UNITED STATES OF AMERICA  
NUCLEAR REGULATORY COMMISSION

In the Matter of )  
 )  
STRATA ENERGY, INC., ) Docket No. 40-9091-MLA  
 )  
(Ross *In Situ* Recovery Uranium Project) )

**JOINT THIRD DECLARATION OF DR. RICHARD ABITZ AND FIRST DECLARATION  
OF DR. LANCE LARSON ON BEHALF  
OF THE NATURAL RESOURCES DEFENSE COUNCIL &  
POWDER RIVER BASIN RESOURCE COUNCIL**

**Well AP-4 – Irigaray, Mine Unit 1 –  
Uranium (mg/L)**

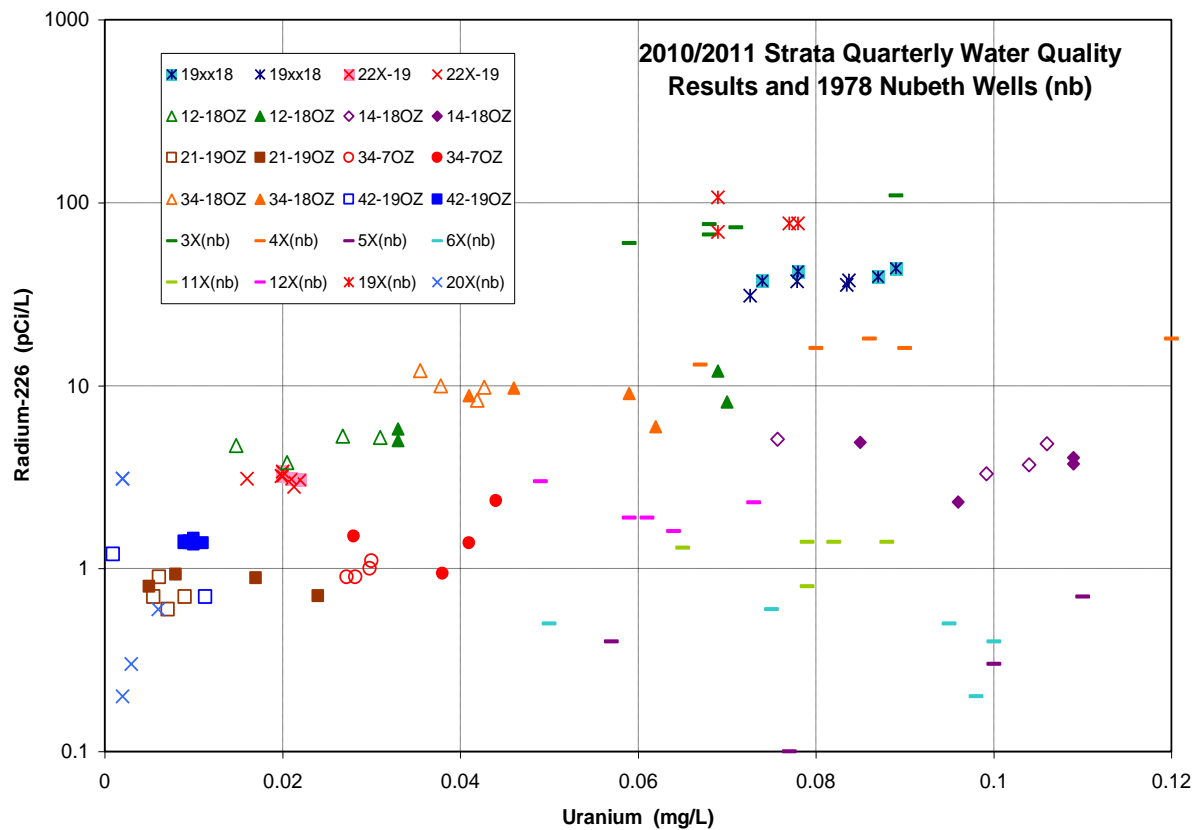
16. Another example where previous ISR mine operators failed to set an accurate baseline – and the problems that emerge from that failure – is found in the data reported for the Irigaray Project, Mine Unit 1 (NRC, 2013b). The uranium concentrations for well AP-4 in Mine Unit 1 display clear evidence of extensive mechanical and chemical disturbance of the aquifer prior to establishing the baseline uranium value (Table below paragraph 16). The average uranium ‘baseline’ concentration at well AP-4 is thermodynamically unfeasible for natural groundwater in contact with uranium ore (uraninite) under reducing conditions (Langmuir 1978); and this conclusion is substantiated by the observation that the ‘baseline’ value is almost 2.5 times higher than the post-mining concentration.

17. Further investigation of operational history at Irigaray demonstrates how the invalid ‘baseline’ was affected by previous mining and exploratory activities. Research and development activities occurred at the Irigaray site in 1975. Specifically, the 517 site and Well Field A (now Mine Unit 1) began pilot operations in 1975 (Staub et al. 1983; p. A-6). Well Field A was ISR mined using an ammonium bicarbonate lixiviant from 1975 to mid-1976 (Staub et al. 1983; p. A-6). According to the 1978 draft environmental impact statement for commercial operations at Irigaray, baseline sample data for Well Field A were taken “from 11/9/76 to 2/24/77” (NRC, 1978). Therefore, the ‘baseline’ data used for Well Field A were collected immediately after pilot-scale research and development mining activities. The implications of approving high ‘baseline’ values in an ISR license are discussed in detail in paragraphs 37-41.

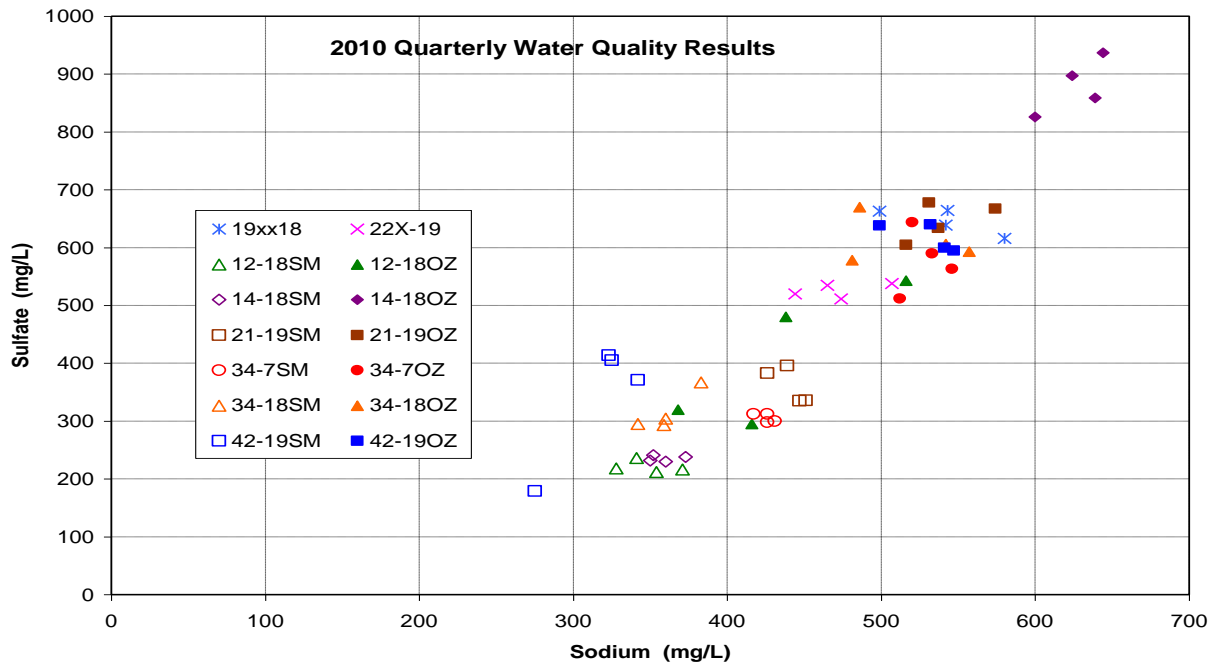
59. Demonstration of adequate hydrologic control is not a trivial matter because groundwater communication between the SM and OZ horizons is evident in the 24-hour pump test data from well 12-18OZ and the water-quality results for sodium and sulfate (Below paragraph 60). Groundwater from the ore horizon (OZ; solid symbols) generally has higher sodium and sulfate, relative to the overlying groundwater (SM). However, mixing of the groundwater from these two horizons is clearly indicated by the linear trace of the sodium and sulfate trend on Figure 2. In our expert opinion this is unquestionably demonstrated by the mid-location of plotted samples from 22X-19, a well that is screened through the OZ and SM zones (Section 2.7.3.3.1, p.2-169, Strata TR). If 14-18OZ is taken as the unmixed groundwater from the ore horizon, all other OZ samples are shown to have a component of SM water, as they lie between 14-18OZ and 22x-19. Note that the strong mixing between the horizons is unequivocal for samples from 12-18OZ, which plot with the samples from 22x-19 and the SM horizon.

60. Water-quality results for sodium and sulfate indicate groundwater mixing of the ore zone (OZ) and overlying horizon (SM).

61. The above figure also illustrates that, the closer that a pair of samples plots for a given cluster well (e.g., 12-18SM and 12-18OZ), the higher the probability for groundwater contamination by communication between the two groundwater zones during ISR operations. In contrast to mixing between the 12-18 horizons, 14-18SM and 14-18OZ samples cluster tightly and are well separated on the plot. An explanation for the distinct separation of the 14-18 horizons on the sodium-sulfate plot may be that the density of exploration boreholes is lower around this cluster well and less communication between the SM and OZ horizons has occurred (*i.e.*, 14-18 may provide a snapshot of the distinct major-ion chemistry of the horizons prior to the drilling of thousands of exploration boreholes).

Fig. 2.8. Alternate interpretations of the same borehole data.

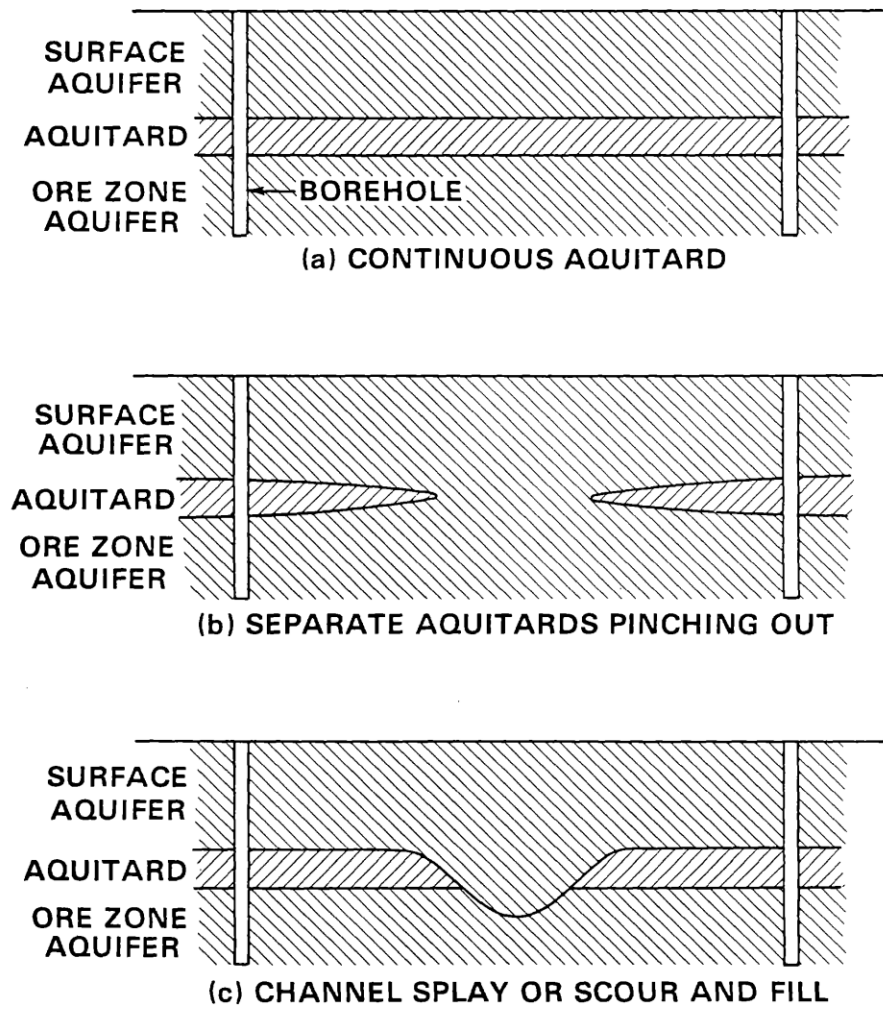
63. Paragraph 62 is supported by the discussion and figure from (Staub et al.1983; p. 24), which provides evidence for alternative interpretations to aquifer tests and the complexities in adequately defining aquifer confinement:

*“Conventional exploration methods as describe above seldom provide enough detail to determine whether an ore zone aquifer is sufficiently isolated from other aquifers. The complex stratigraphy of alluvial sediments is a serious obstacle to projection of lithologic units between boreholes even at short distances. Figure 2.8 [original document; see below] presents several interpretations of the same data. In the absence of proof of the contrary, stratigraphic units are often projected as continuous layers between boreholes which may lead to a false sense of security with respect to aquifer isolation. Furthermore, two-dimensional cross-sections do not necessarily portray accurate relationships between aquifers in three dimensions. Thus, an aquitard may be continuous in one direction and discontinuous in another.”* (Staub et al. 1983) (page 24).
